Our Ref: 191544

RE: SSD-9138102 Westlink Industrial Estate at 290-308 Aldington Road, 59-62 Abbots Road & 63 Abbots Road, Kemps Creek

Sydney Water provides updated stormwater advice (below) following nomination as the stormwater authority and in line with the revised proposal.

Diagram 1: Site location and Mamre DCP identified drainage infrastructure

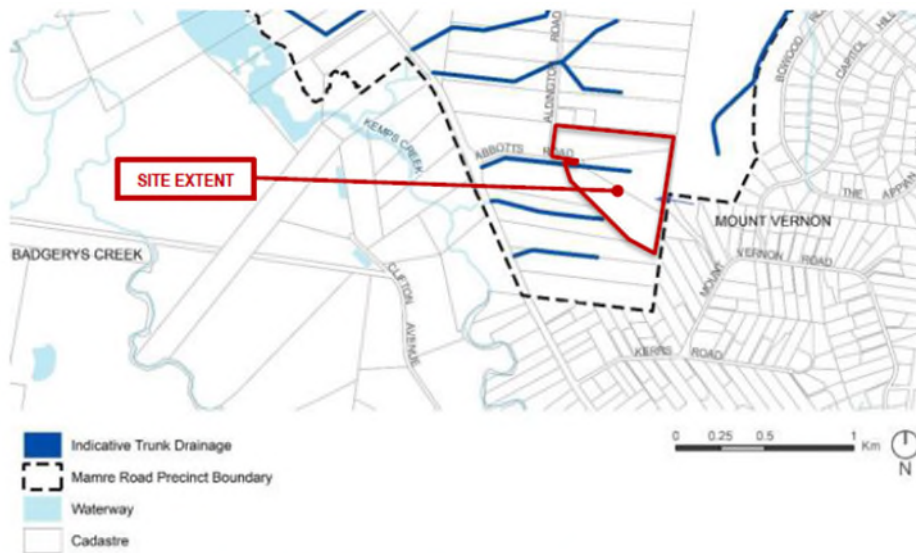
Sydney Water will permit a minor reduction in the planned open natural trunk drainage channel extent to allow the open channel to initiate downstream of the proposed internal (North/South) road.

- The open natural trunk drainage channel within the site, which has been identified by Sydney Water and the Proponent (as above) and which will be managed by Sydney Water *must* be reflected in the Proposal. Right of access will be required to allow Sydney Water to manage and maintain the asset in perpetuity.

Diagram 2: Relevant excerpt from December 2022 update of Sydney Water's Stormwater Scheme Plan part 1.

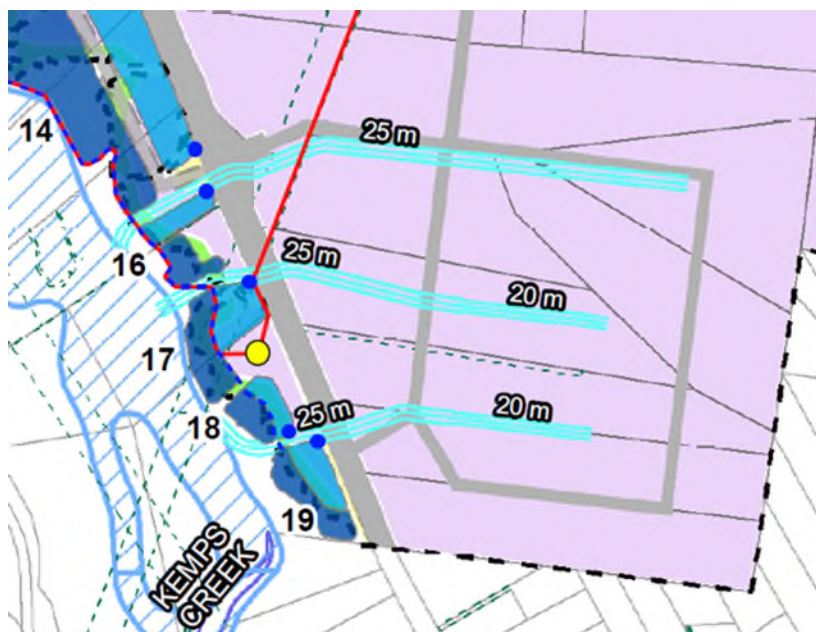
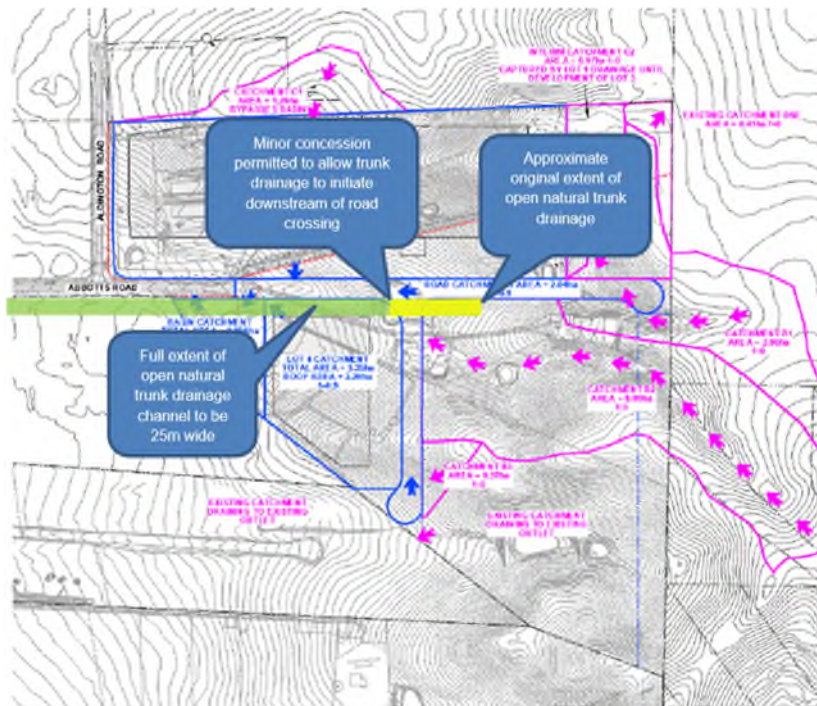
- Sydney Water will not accept private OSD or interim stormwater retention storage in the naturalised trunk drainage channel. The proposal currently has an OSD basin shown where the trunk drainage channel is required. **This will need to be amended.**
